STAFF REPORT

Department of Metropolitan Development Division of Planning Current Planning Section

Case Number: 2023-ZON-109
Address: 5136 Michigan Road (*Approximate Address*)
Location: Washington Township, Council District #8
Petitioner: Paramount Schools of Excellence, Inc., by Timothy Ochs
Request: Rezoning of 10.13 acres from the SU-1 district to the SU-2 district to provide for educational uses.

ADDENDUM FOR FEBRUARY 29, 2024 HEARING EXAMINER

PROPOSED SITE PLAN
 SHEET NO. 001
 TOTAL SHEETS 010
C1

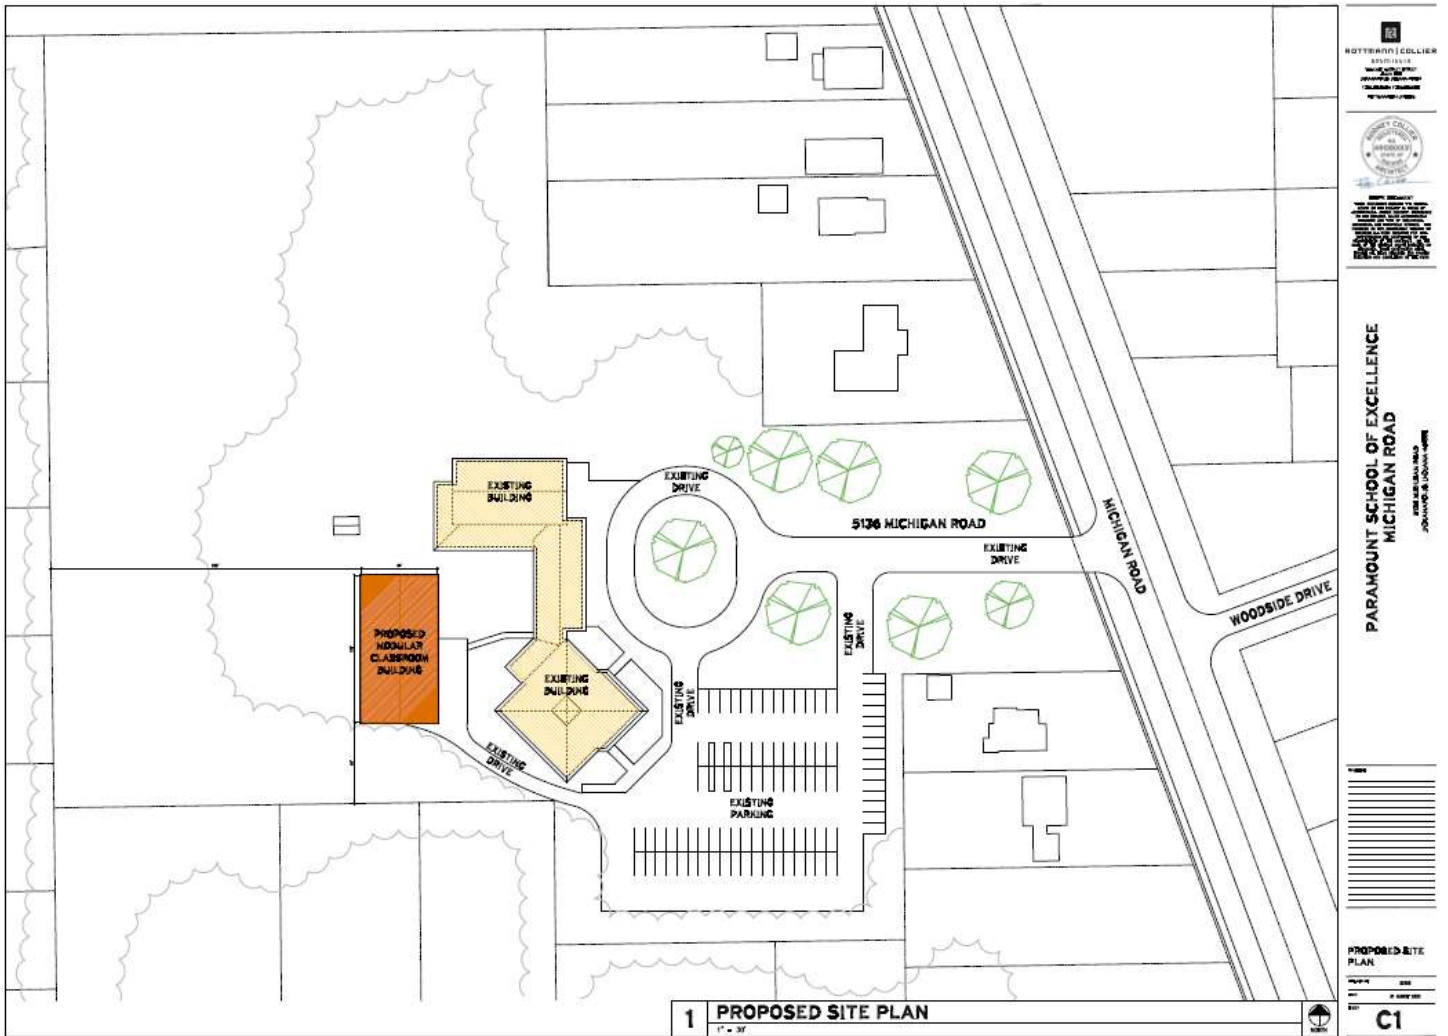
Traffic impact studies were submitted to staff on February 5, 2024 and were provided to the Department of Public Works for comments. The petitioner's traffic study results showed that delays in service would drop during the morning and evening peak time and during the school dismissal peak time. It was determined that the existing Michigan Road right-of-way has adequate width to have northbound and southbound turn lanes added. DPW did not see that a traffic control signal would be necessary at this location. There is concern with a traffic control officer being on this street, but a left turn lane would allow space for an officer's vehicle to park.

4. A queuing plan shall be provided to Program Manager – Multi-Modal for the Department of Public Works – Engineering that demonstrates adequate storage for parent drop off/pick up vehicles on site without overflow onto Michigan Road.

1. The driveway shall be constructed with one lane entering and two lanes exiting per commercial driveway standards within 12 months of issuance of an Improvement Location Permit (ILP).

2. A north bound left turn lane and south bound right turn lane shall be installed per DPW and INDOT standards. Traffic study figures should be used to determine storage length. The turn lanes shall be installed within 12 months of issuance of an Improvement Location Permit (ILP).
